SIB 11 05 25

DELIVERY STOP: S68T ENGINE - REPLACE UPPER OIL PAN SCREWS

This Service Information Bulletin (Revision 3) replaces SI B11 05 25 [AM1] [MM2] dated August 2025.

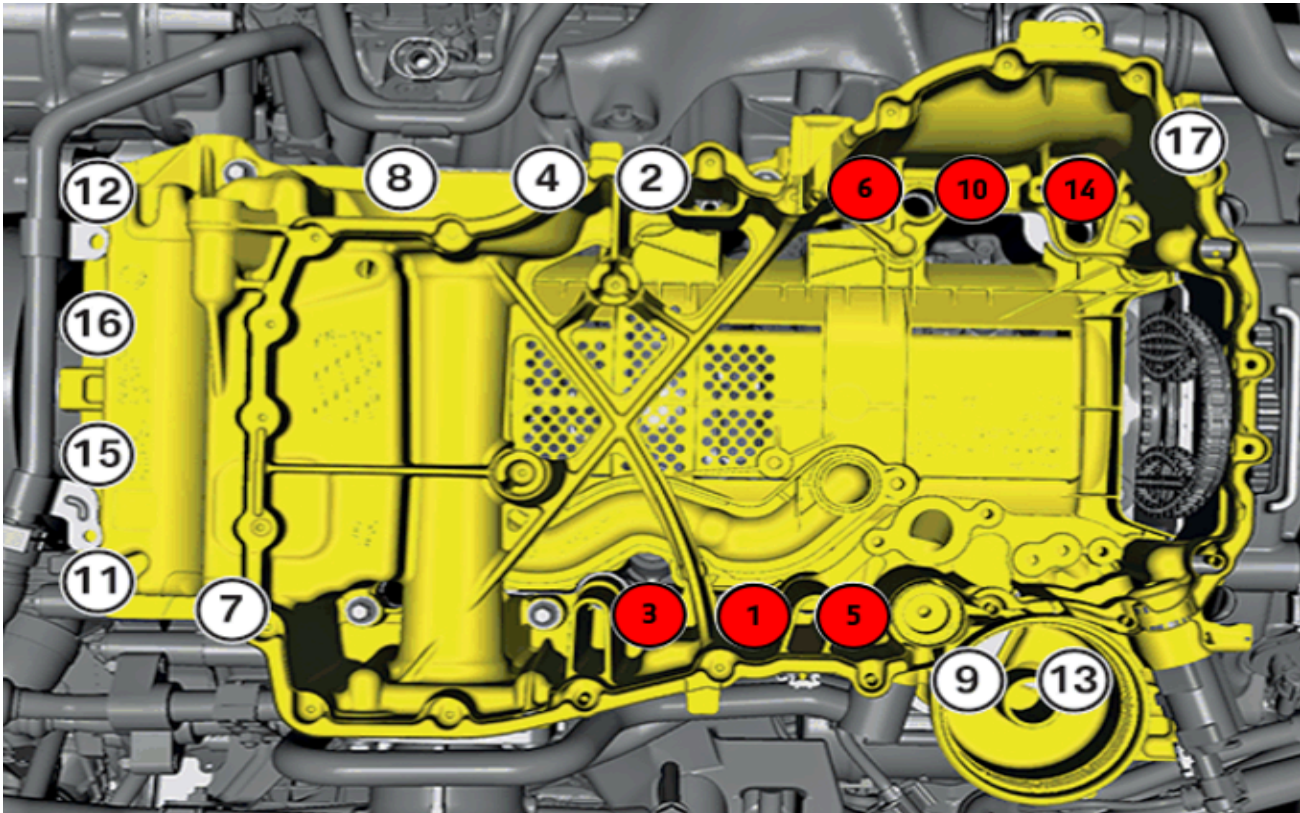
Due to an assembly error the upper oil pan screws may not have been torqued correctly.

Do not remove the upper engine oil pan or the engine oil pump from the vehicle. Follow the supplemental instructions in the next step to replace each of the 6 affected screws one at a time after the lower oil pan is removed.

Only 6 screws are affected by this Delivery Stop.

2. Remove, replace and torque each screw **one at a time** using the sequence of numbers in the illustration below. Only replace the 6 screws highlighted in red.

Replace the 6 affected screws in positions 1, 3, 5, 6, 10 and 14 in that order only.

1. Replace 6 specific upper oil pan screws with P/N 07 11 9 908 428 using Repair Instruction 11 13 020 “Remove and Install Lower Oil Pan Section”.

Torque the 6 new screws to the following:

Joining Torque: 10 Nm

Angle Torque: 90 degrees
